New CPE 3 Pole HV connector

Inspected on 13 Jan 2012

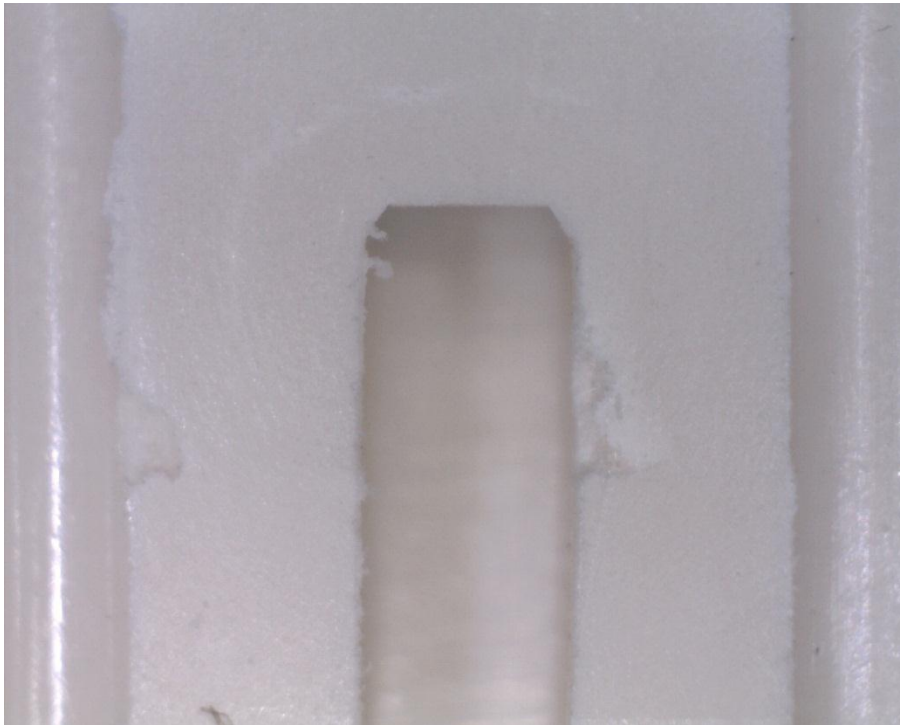
The void size is clearly smaller than all other versions $\sim 0.2\text{mm}$.

The older versions $>1\text{mm}$;

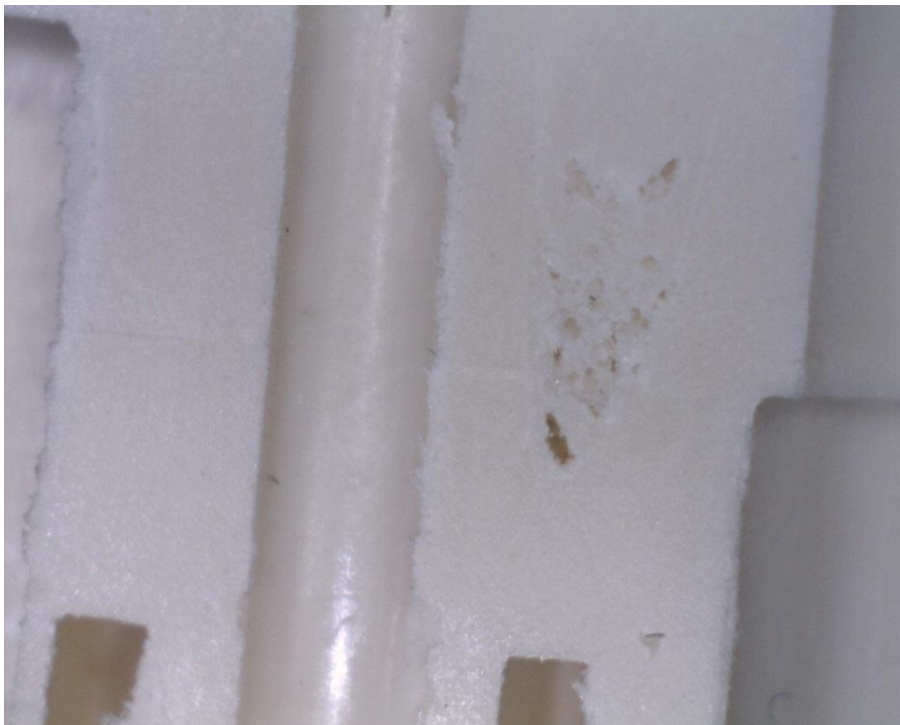
However there are other defects on the insides of the mould;

Porosity over 0.9mm in length.

Closer inspection reveals rough surfaces ?;

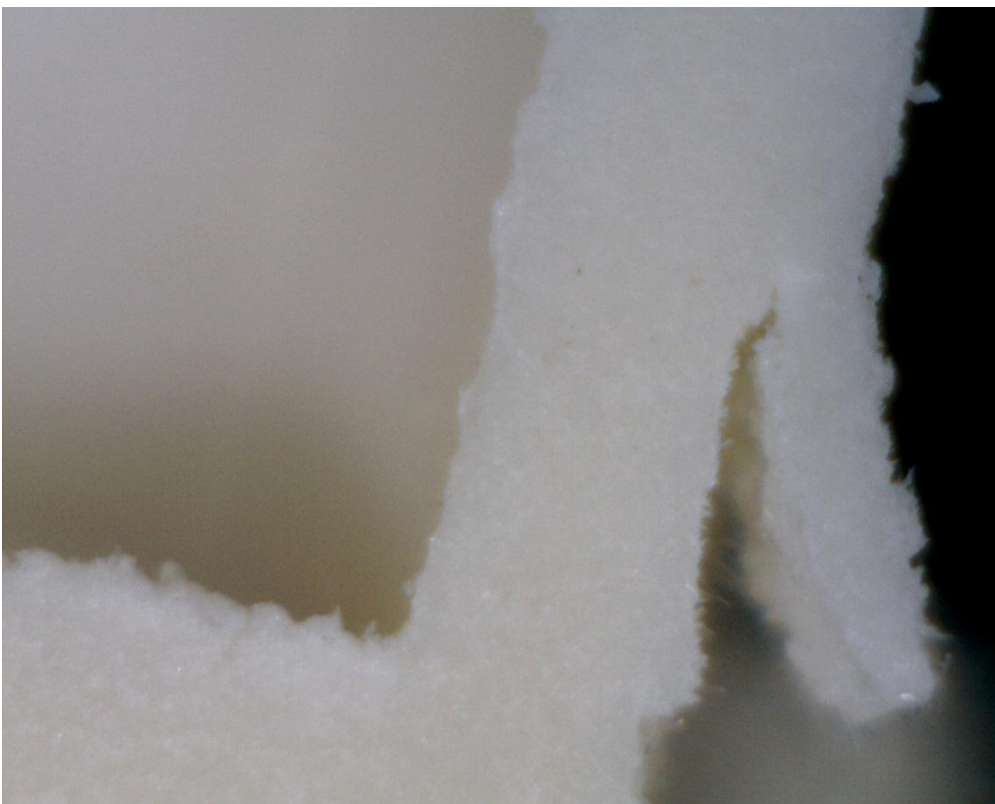
And brittle fracture growth.

The pieces are non-pliable, unlike the older versions that are very elastic.

Brittle fracture is evident with low strength.

It would appear that the new version has been heat treated in a manner to form excess crystal growth, in an attempt to make the material more fluid for better mould filling as opposed to the older versions that remain more amorphous. The higher crystalline content may decrease electrical conductivity while reducing breakdown voltage.

I would not recommend this material/heat treatment for the 3 pole HV connector.
